ADDENDUM NO. 02

Project: Conway Corporation
Roger Q Mills Jr.
Water Treatment Plant 8 MGD Expansion & Improvements

The Contract Documents dated May 3, 2024, are hereby amended as follows:

DRAWING NUMBER 10-E601

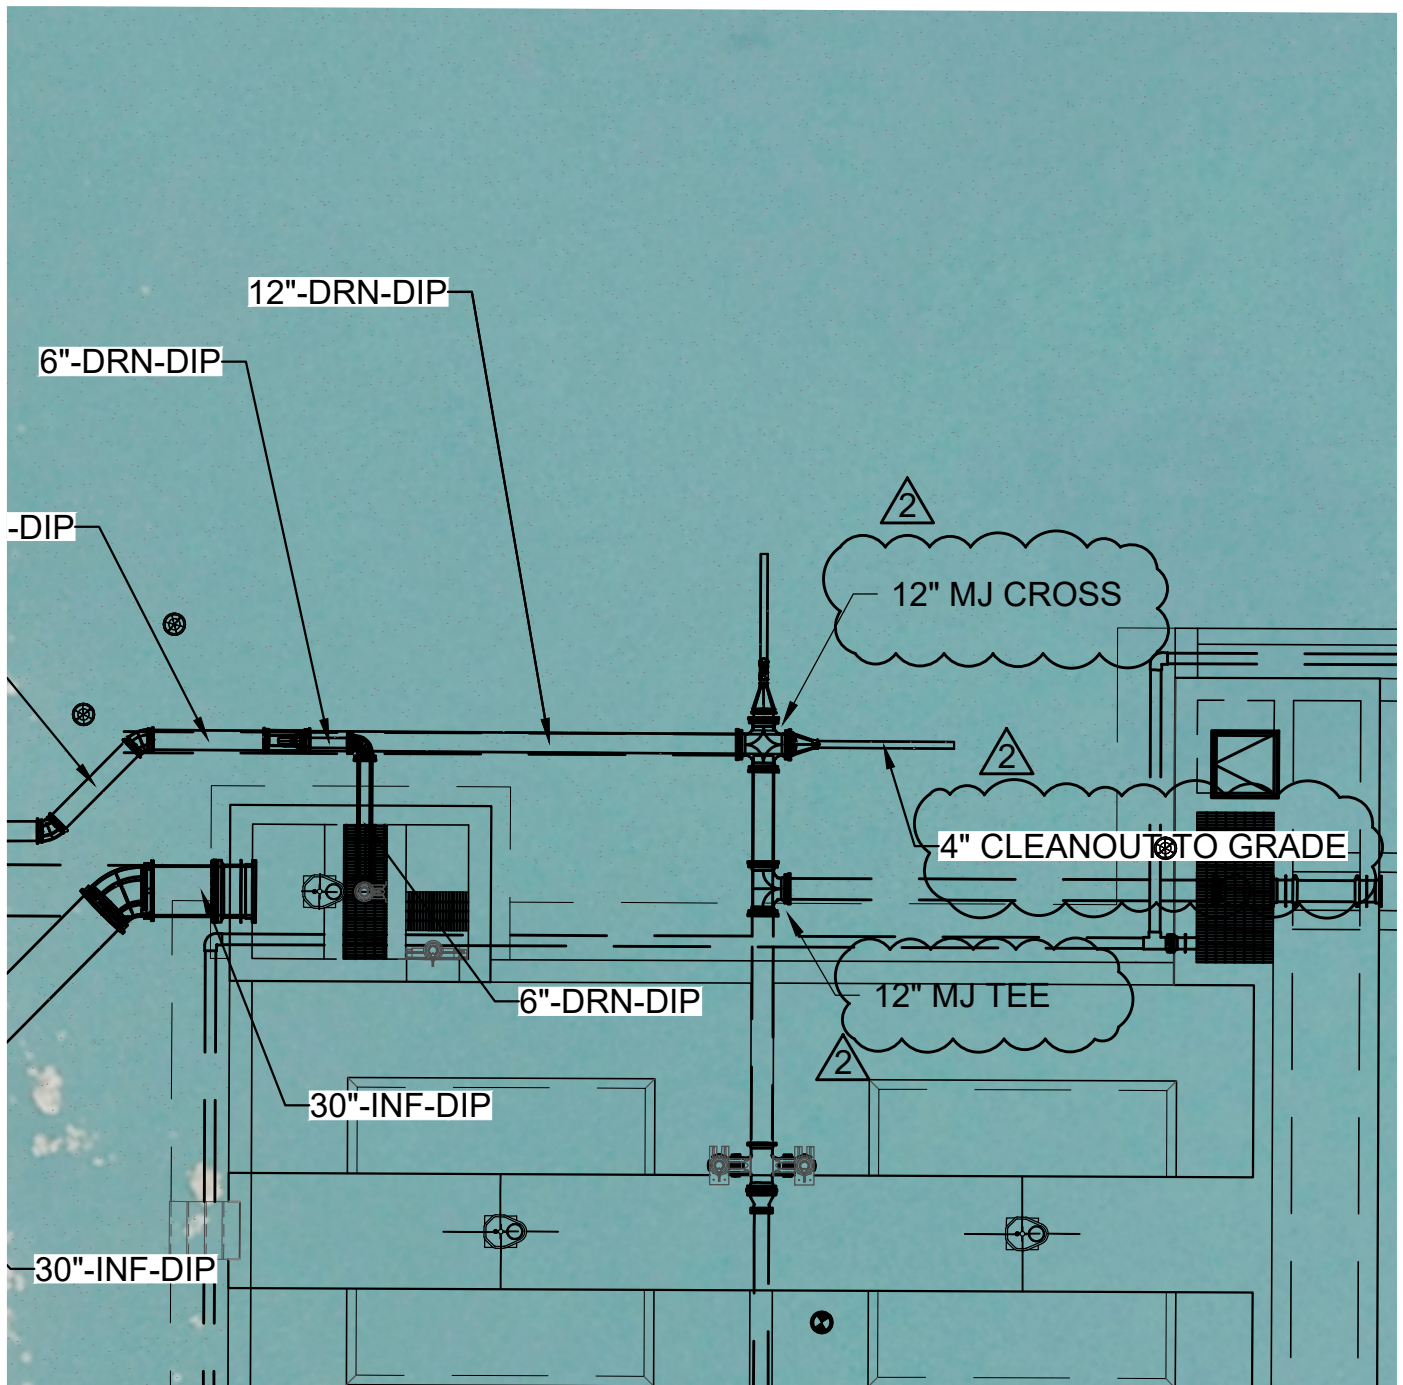
15. Drawing No. 10-E601 (Sheet No. 089)
 - a. Delete the entire drawing and replace it with Drawing No. 10-S301 - RAW WATER BLENDING STRUCTURE ELECTRICAL SCHEDULES- Addendum No. 02, attached hereto.

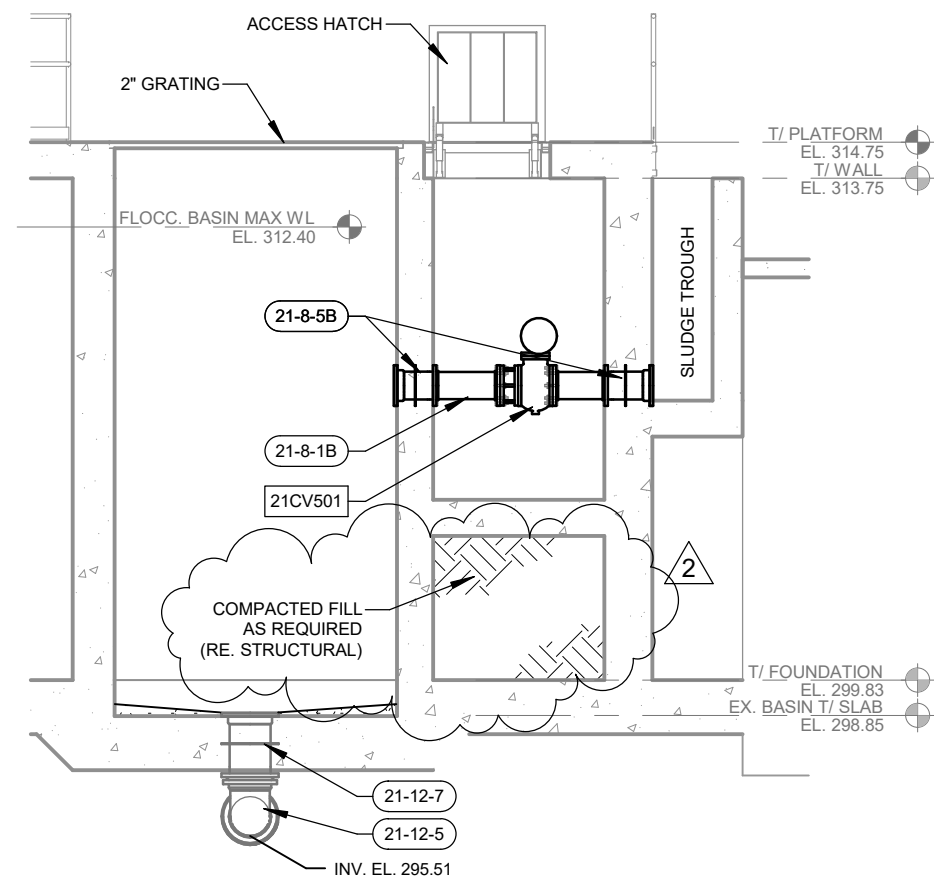
16. Drawing No. 21-C300 (Sheet 112)
 - a. Modify the Flocc Influent and Drain shown on the New Plan Flocculation Piping Plan and Profile – Addendum No. 02, attached hereto.

2 SECTION - SLUDGE COLLECTION BASIN A
21-P304 SCALE: 3/16" = 1'-0"

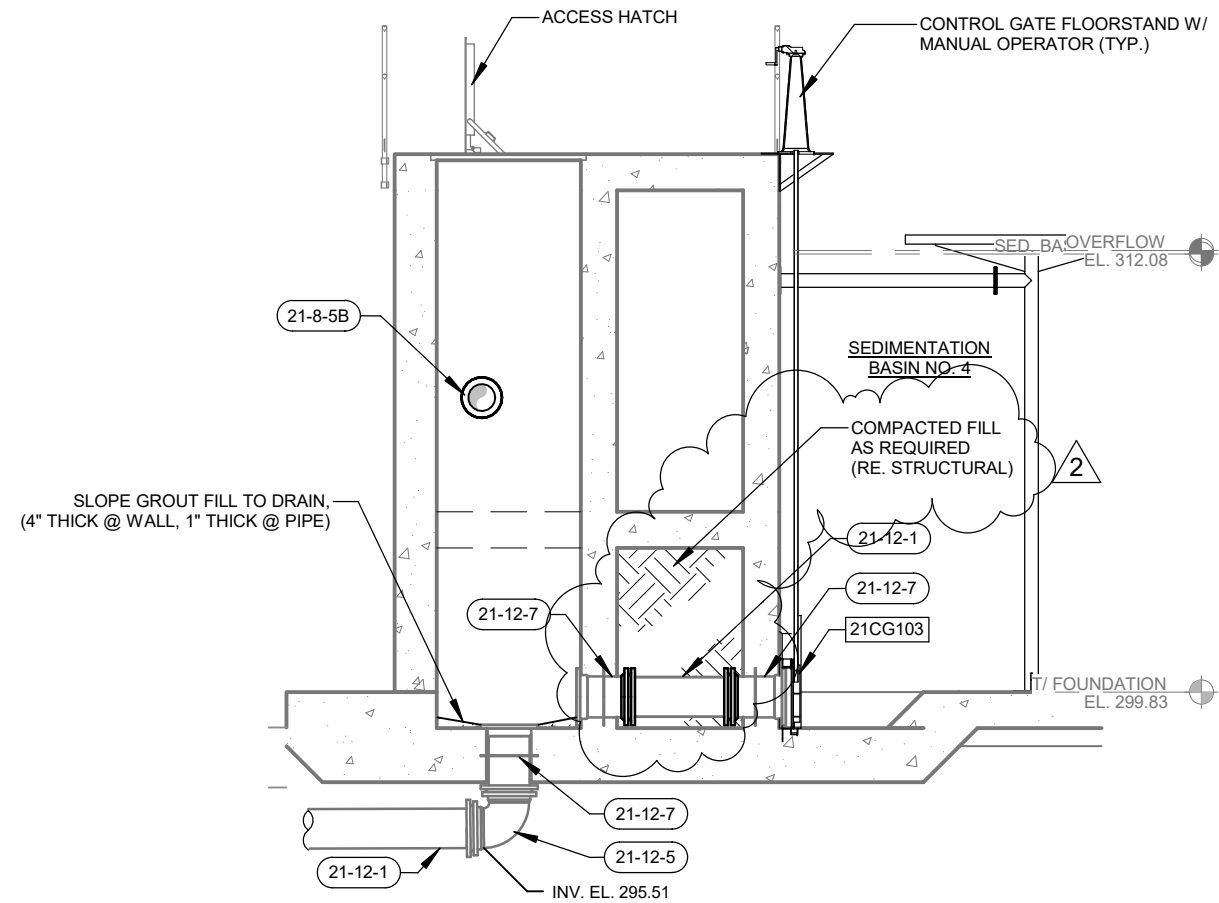
17. Drawing No. 21-P304 (Sheet No. 134)
 - a. Modify the Section – Sludge Collection Basin A and Section – Sludge Collection Basin B shown on New Plant Sedimentation Basin No. 04 – Enlarged Plan and Section 2 Sludge Collection Basin – Addendum No. 02, attached hereto.

CEI JOB NO.: 2135
GARVER JOB NO.: 19W01300
DRAWING NUMBER
21-E101
SHEET NUMBER **139**

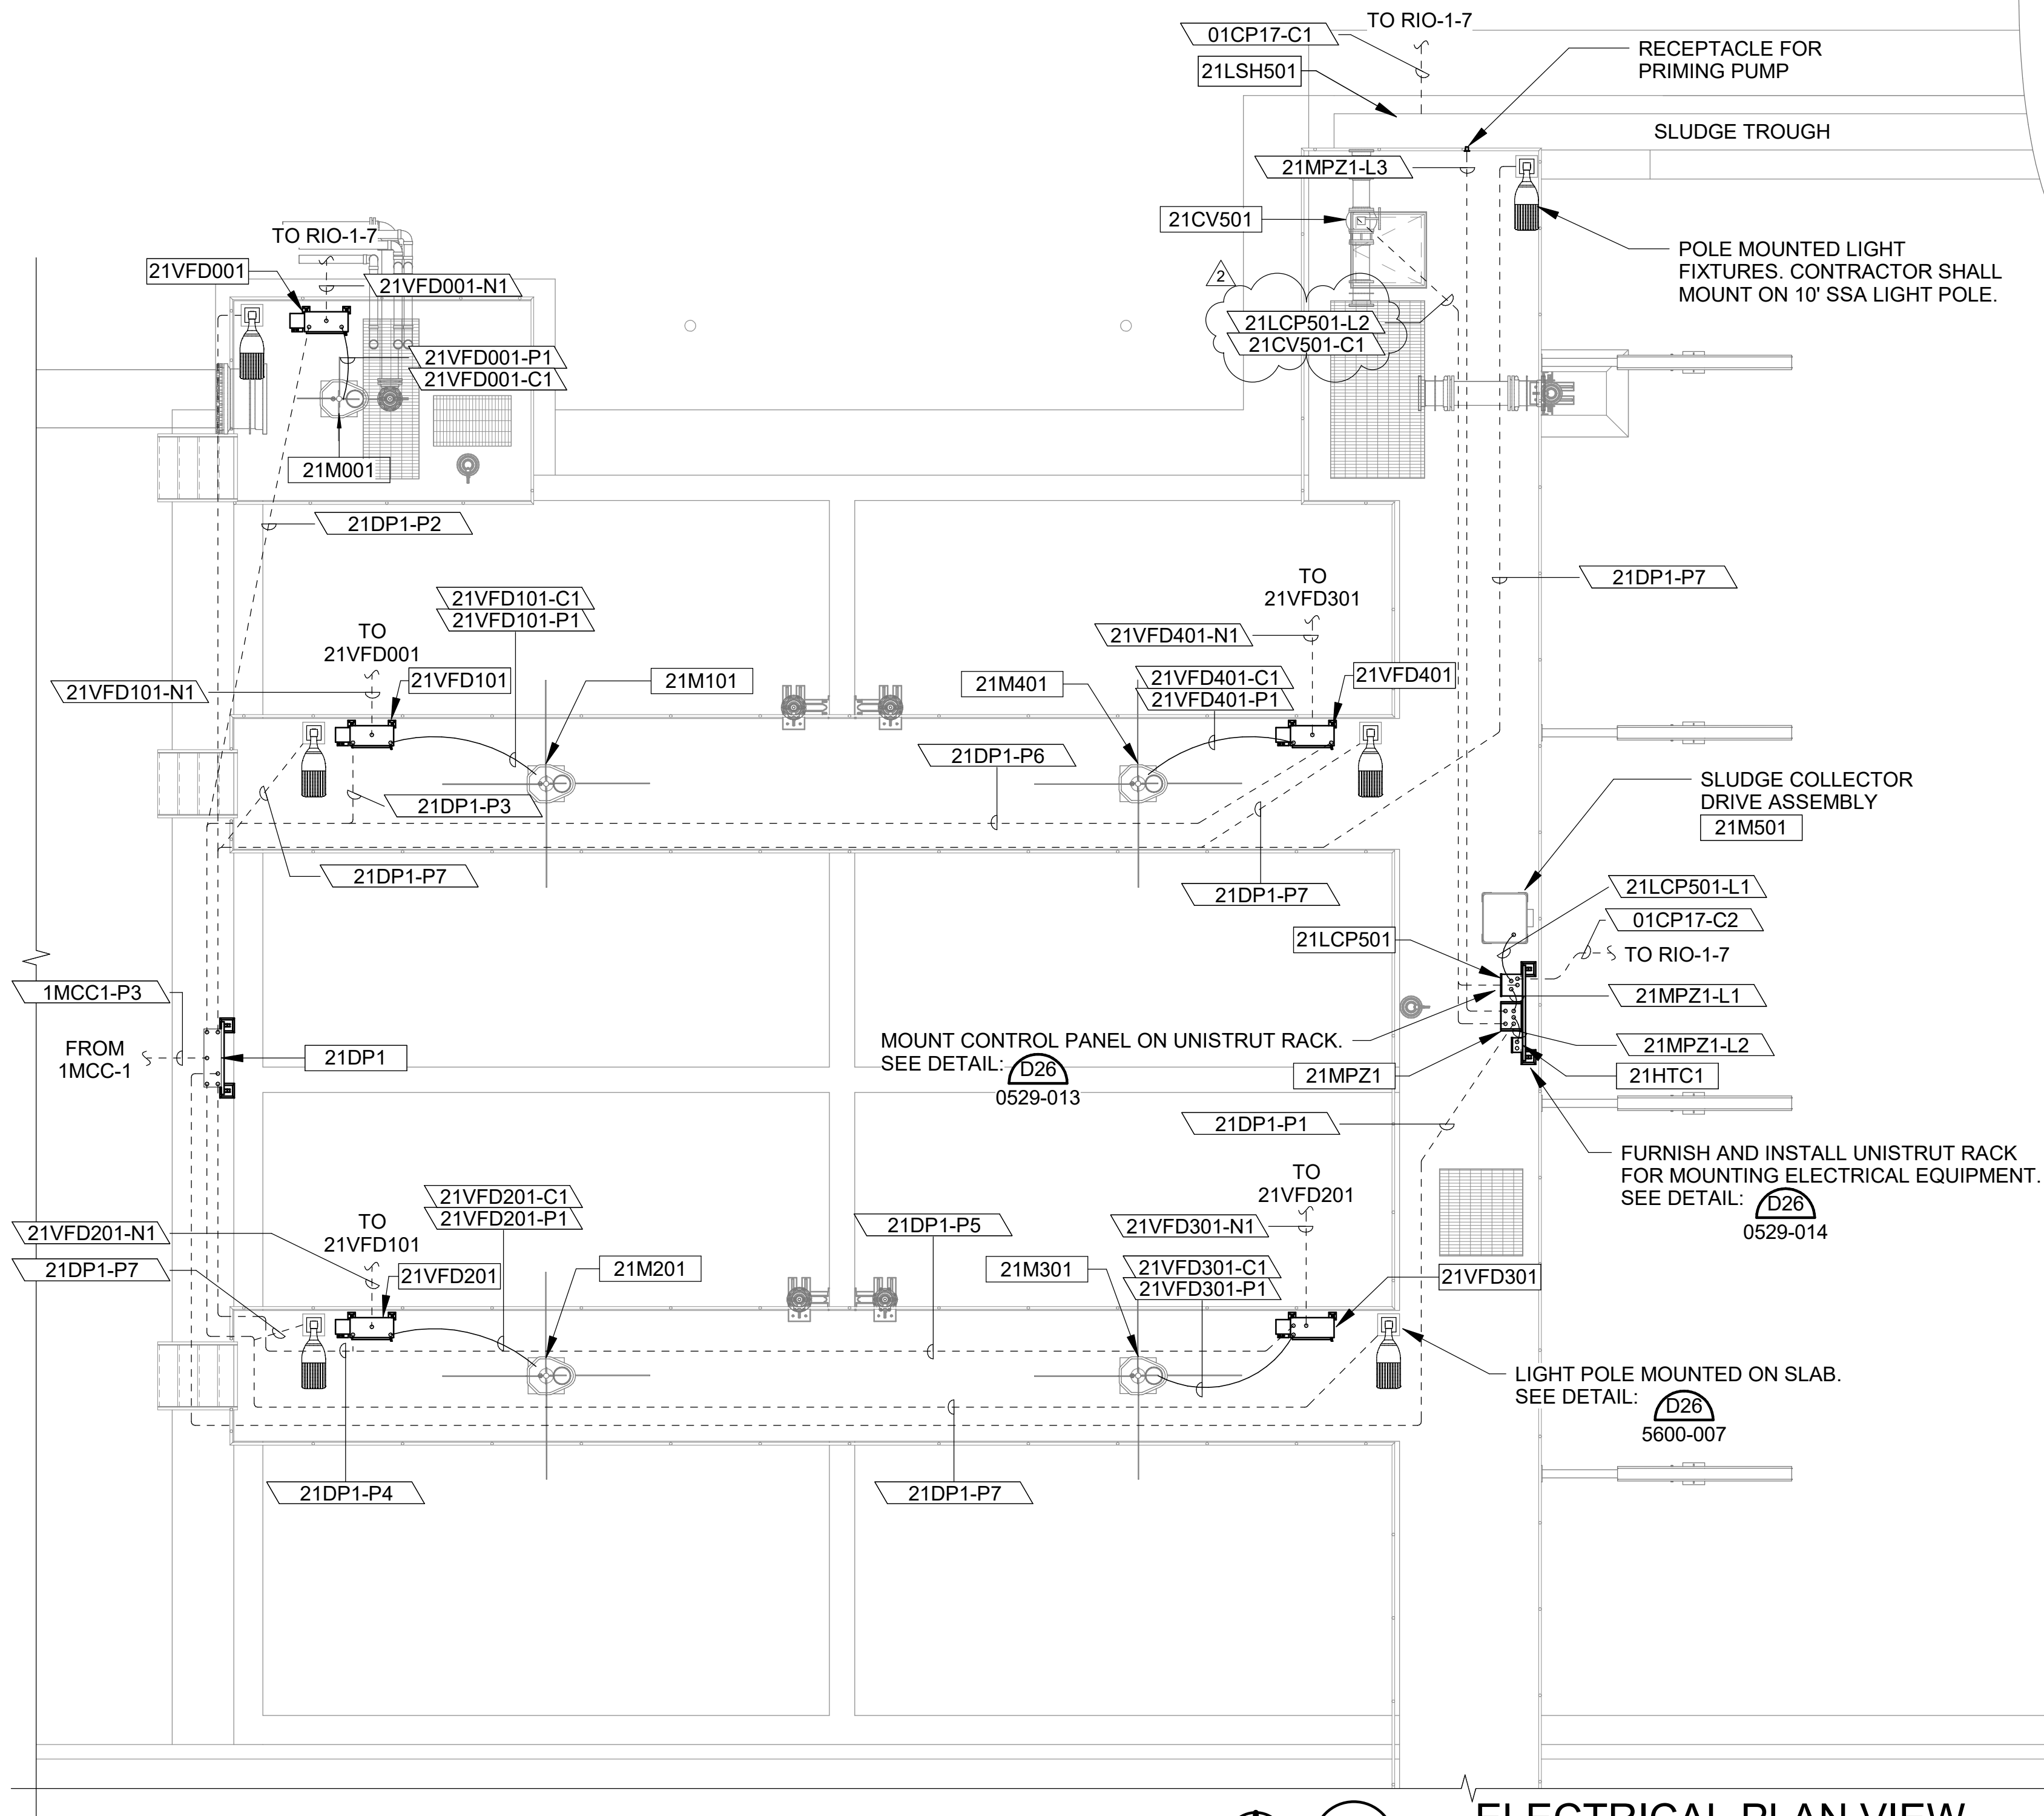
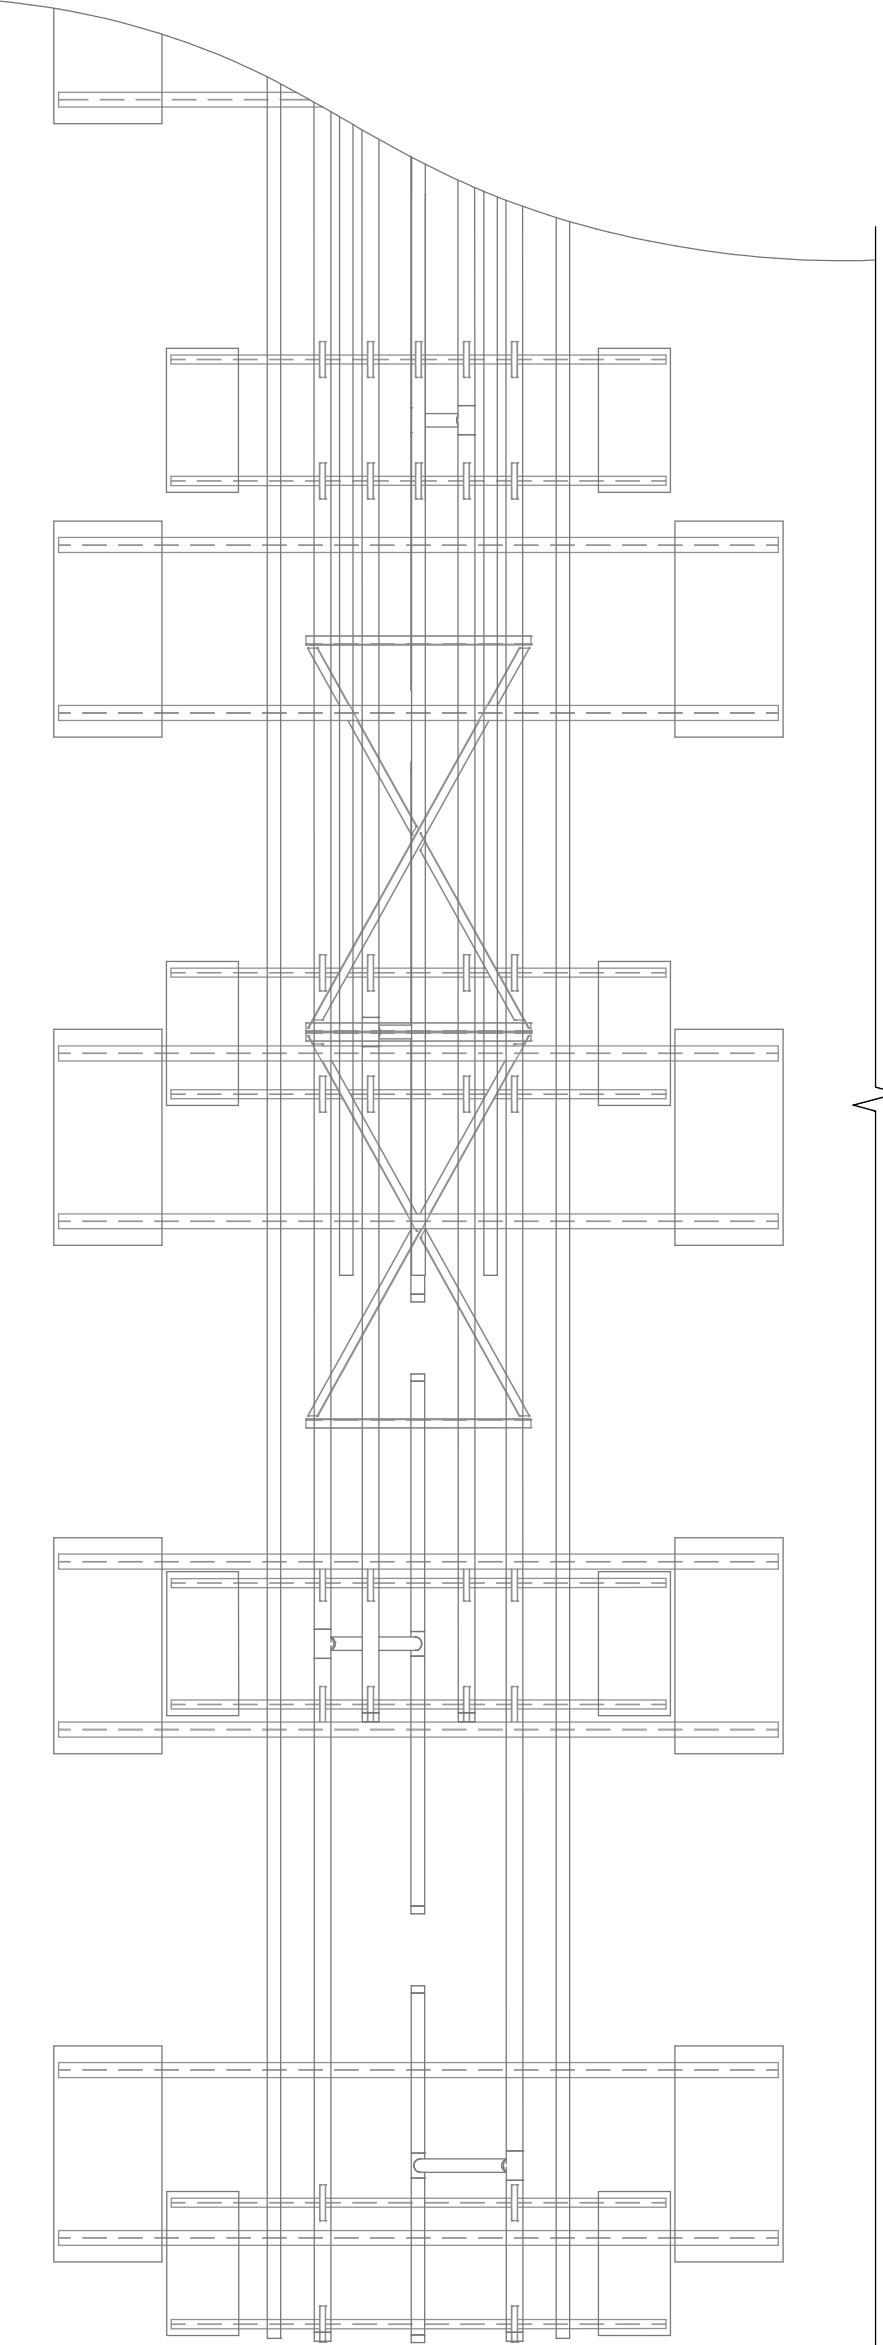
18. Drawing No. 21-E101 (Sheet No. 139)
 - a. Delete the entire drawing and replace it with Drawing No. 21-E101 - NEW PLANT RAPID MIX/FLOCCULATION/SEDIMENTATION ELECTRICAL POWER PLAN 1- Addendum No. 02, attached hereto.
